Docket Number:	09-AFC-06C
Project Title:	Blythe Solar Power Project - Compliance
TN #:	233730
Document Title:	Statement of Staff Approval of Post Certification Change
Description:	Statement of Staff Approval of Post Certification Change Blythe Solar Power Project
Filer:	Susan Fleming
Organization:	California Energy Commission
Submitter Role:	Commission Staff
Submission Date:	7/2/2020 4:01:32 PM
Docketed Date:	7/2/2020

STATEMENT OF STAFF APPROVAL OF POST CERTIFICATION CHANGE Blythe Solar Power Project (09-AFC-06C)

Area Proposed to be Removed from Amended Blythe Solar Power Project Site

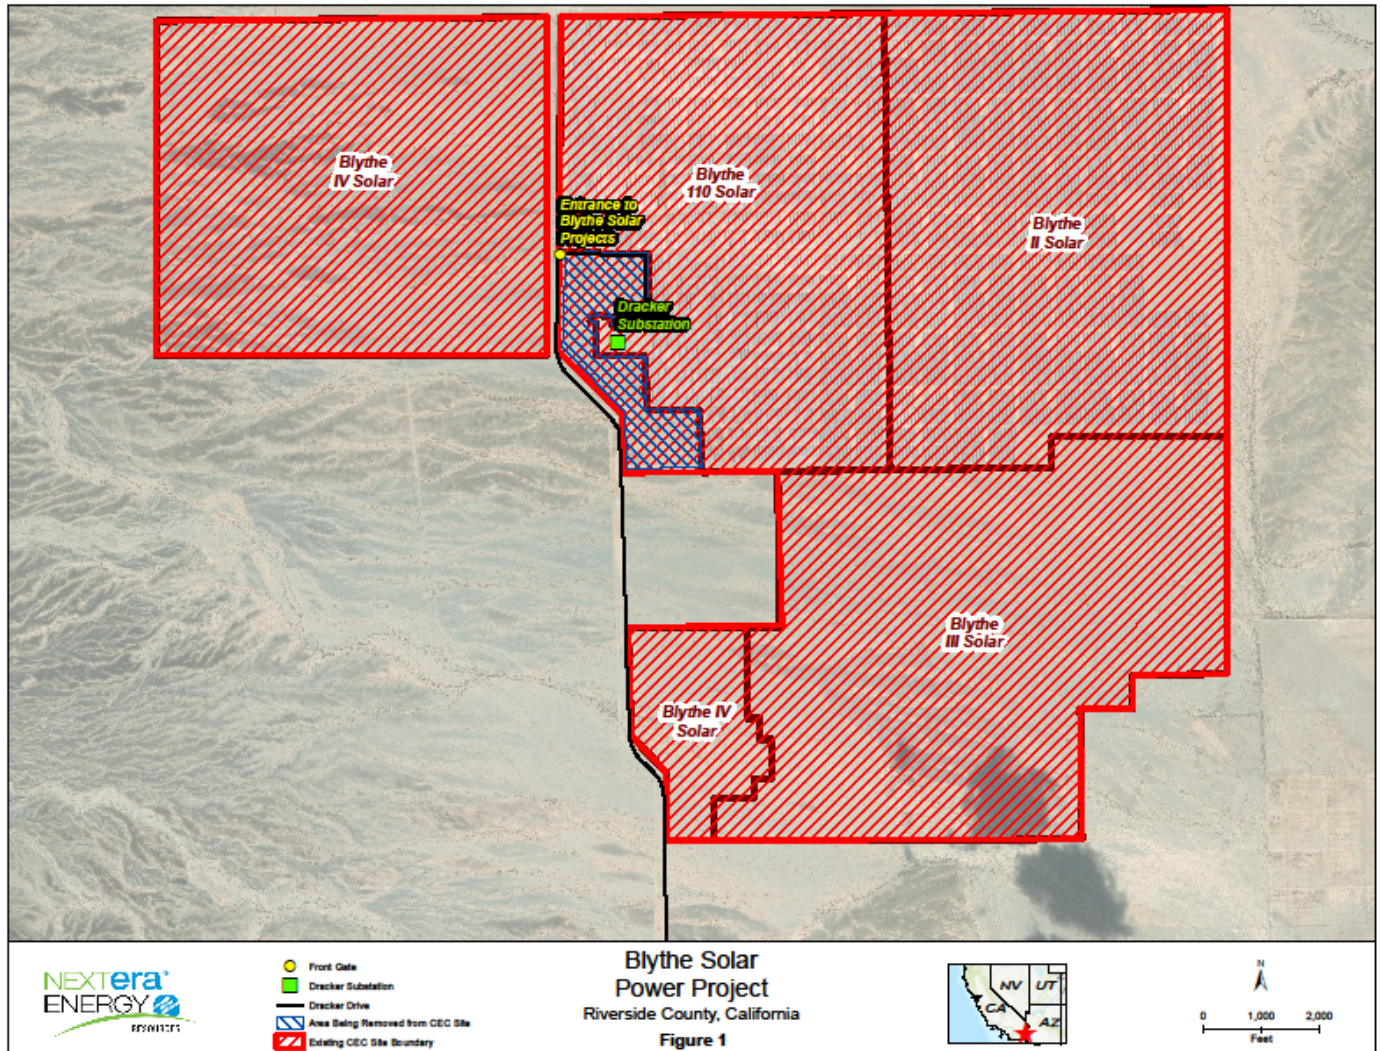
The petition requests the site boundary be modified to eliminate approximately 94 acres of land in the western portion of the site, just east of Dracker Drive, as described in the Decision. The land proposed for removal from the project site currently contains transitory uses, including parking, laydown/staging, and contractor trailers supporting the construction of BSPP. Despite the fact that the land would no longer be included within the boundaries of the licensed BSPP, all conditions of certification in the Decision would remain in full force and effect.

Proposed New Configuration of Amended Blythe Solar Power Project Site

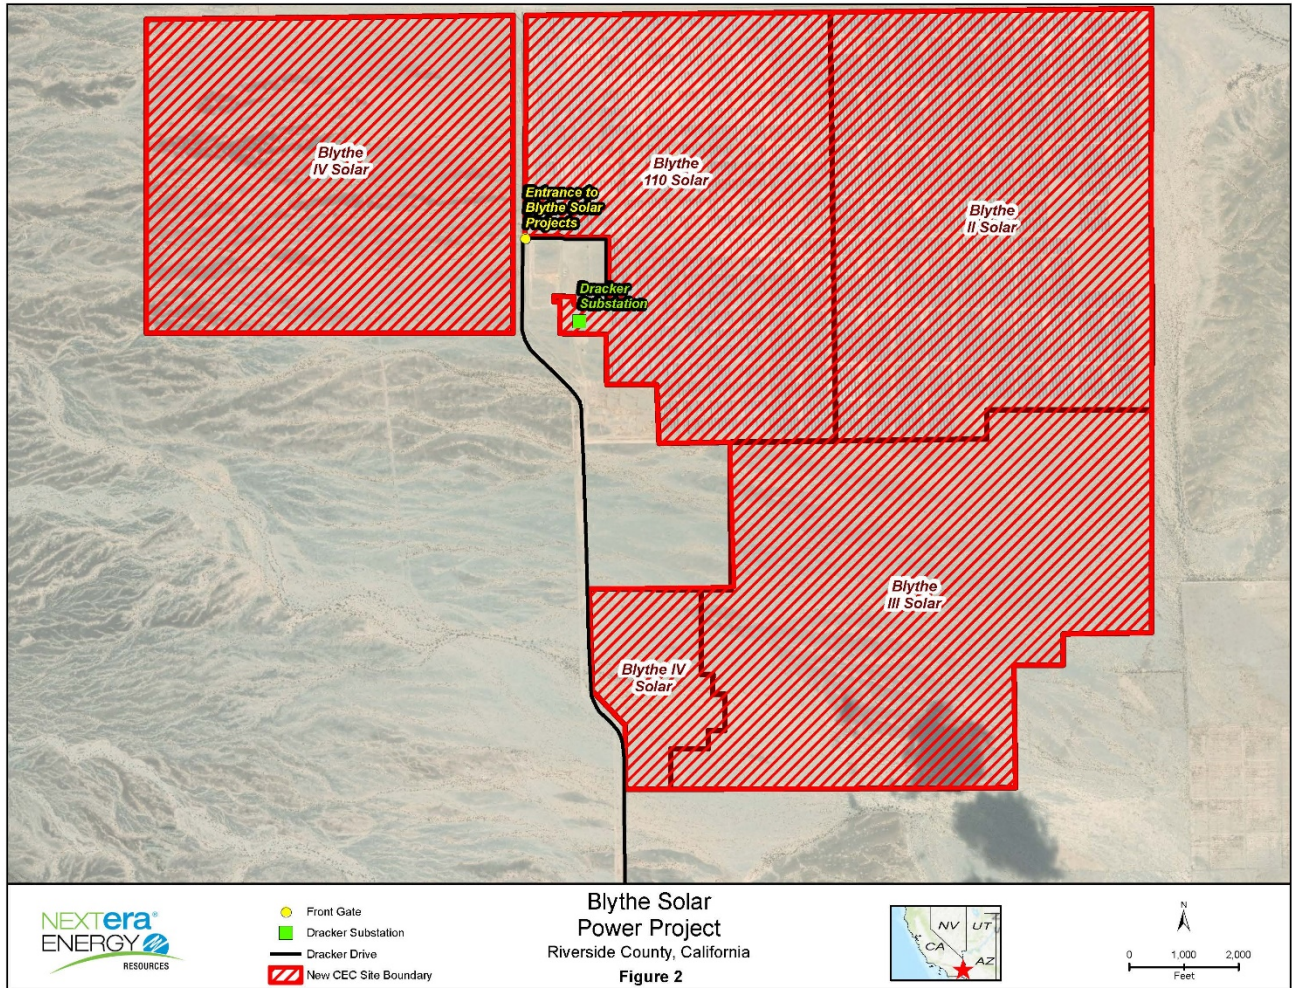
Relocating the westernmost boundary of BSPP would make additional property available for the development of the battery storage facility, facilities not directly connected to the solar fields. The battery storage facilities would not be subject to CEC jurisdiction and would be permitted by BLM through its right-of-way grant administration process. The battery storage facilities were not anticipated when the project was initially licensed. All lands before and after the property boundary adjustment would still be located on public land located entirely within the BLM right-of-way grant No. CACA-048811.

Environmental Justice-Figure 1

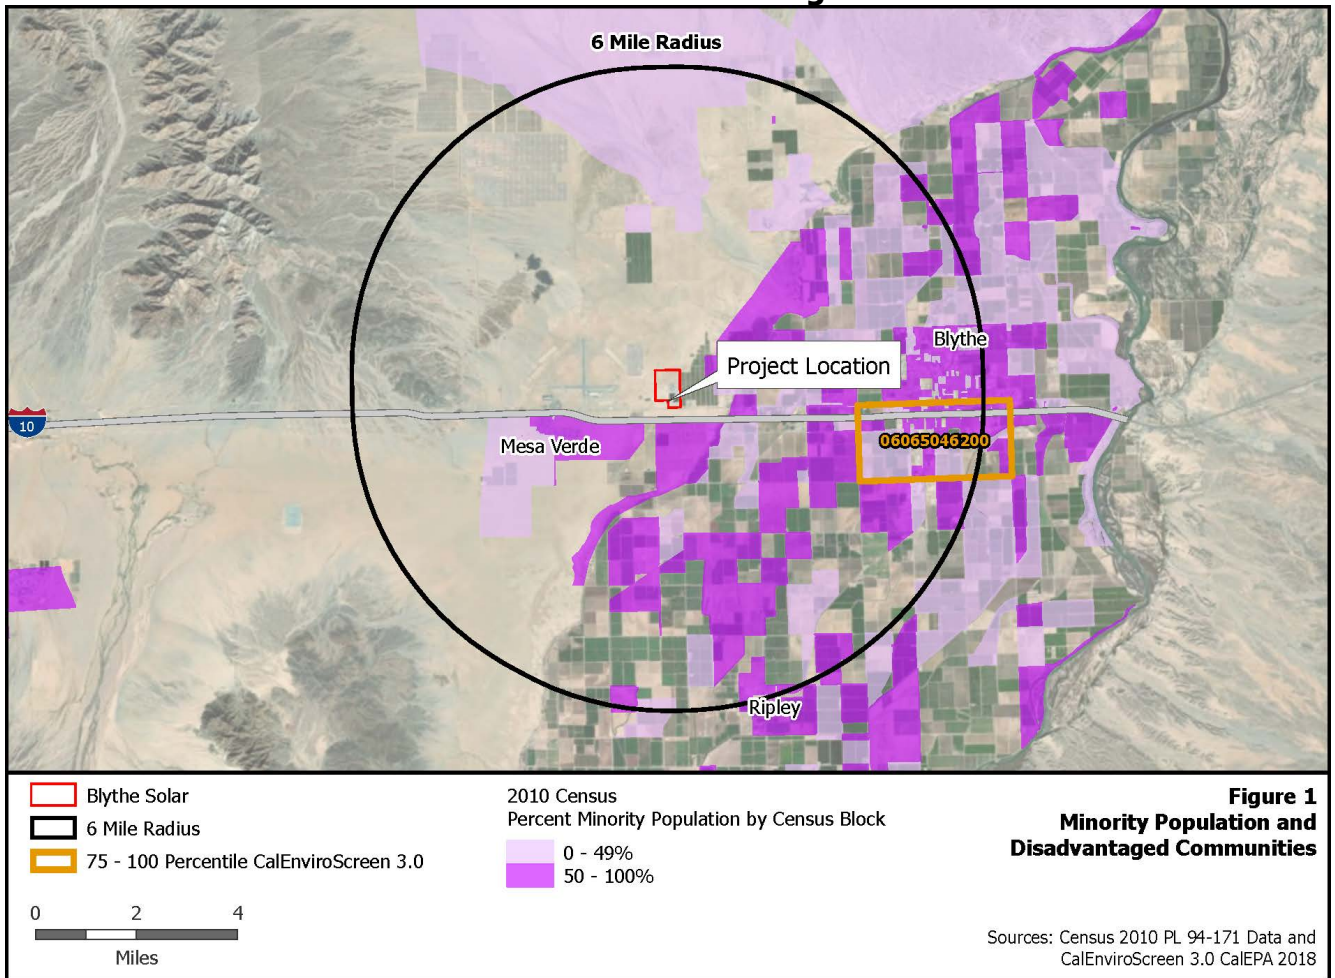
Environmental Justice – Figure 1 shows 2010 census blocks in the six-mile radius of the Amended Blythe Solar Power Project with a minority population greater than or equal to 50 percent. The population in these census blocks represents an environmental justice (EJ) population based on race and ethnicity as defined in the United States Environmental Protection Agency’s *Guidance on Considering Environmental Justice During the Development of Regulatory Actions*. Staff conservatively obtains demographic data within a six-mile radius around a project site based on the parameters for dispersion modeling used in staff’s air quality analysis. Air quality impacts are generally the type of project impacts

None of the technical areas that consider impacts to EJ populations are affected by the proposed project change. Thus, there would be no impacts on any population in the project’s six-mile radius, including the EJ population represented in **Environmental Justice – Figure 1, Figure 2, and Table 1**.
